PROPOSAL REQUEST

PROJECT:	LXT Hangar 2 Eastside Development	PROPOSAL NO:	10
OWNER:	City of Lee's Summit	DATE OF ISSUANCE:	04/01/25
TO:	Fogel-Anderson Construction 1212 E. 8th Street Kansas City, MO. 64106	ARCHITECT:	Wellner Architects, Inc. 1627 Main Street, #100 Kansas City, MO 64108
COPY:	File		
CONTRACT FOR:	General Construction	ARCHITECT'S PROJECT:	2219
CONTRACT DATE:

E302

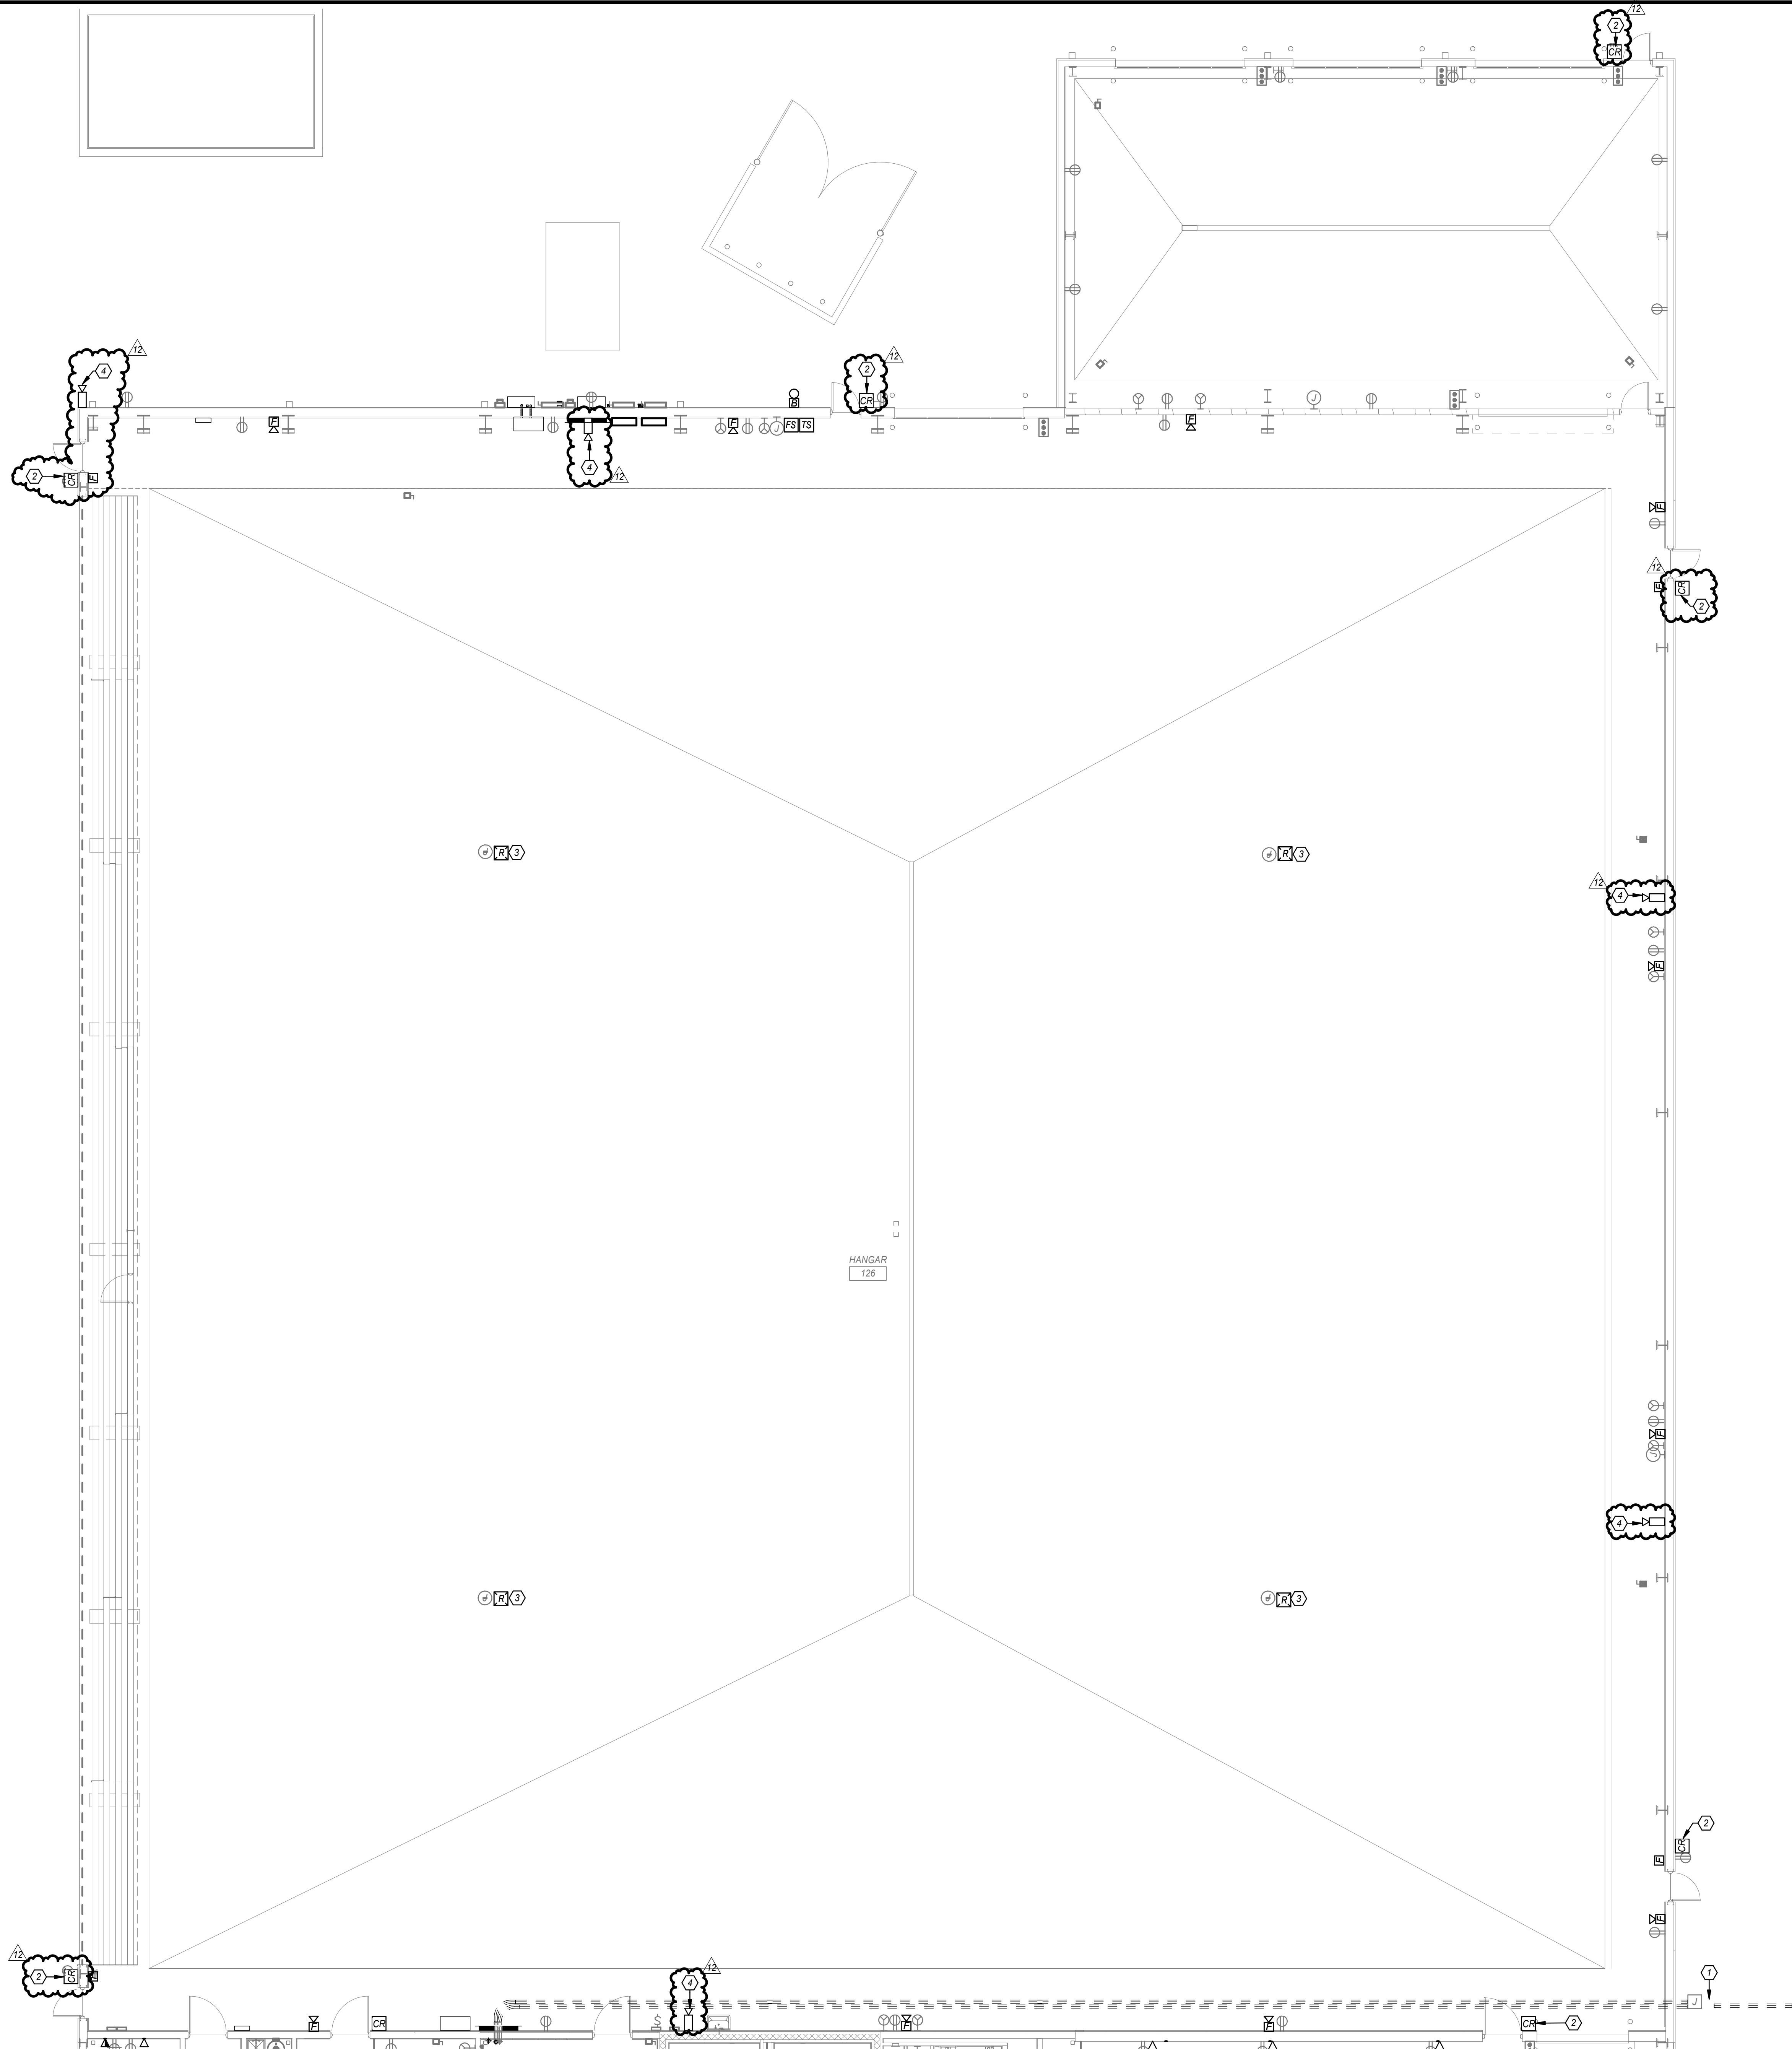
Item 5. SHEET E302 SYSTEM HANGAR PLAN:

HANGAR rm 126 **Add** box and conduit card reader at door 117-A.

HANGAR rm 126 **REVISE** location of box and conduit card reader at door 126-C to other side of the door.

HANGAR rm 126 **Add** box and conduit card reader at door 126-D.

HANGAR rm 126 **Add** box and conduit card reader at door 126-E.

HANGAR rm 126 **Add** box and conduit card reader at door 126-A.

HANGAR rm 126 **Add** box and conduits for cameras at east wall (2), south wall and north wall

GSE STORAGE rm 127 **Add** box and conduit card reader at door 127-A.

EXTERIOR **Add** box and conduits for camera at northwest corner of building.
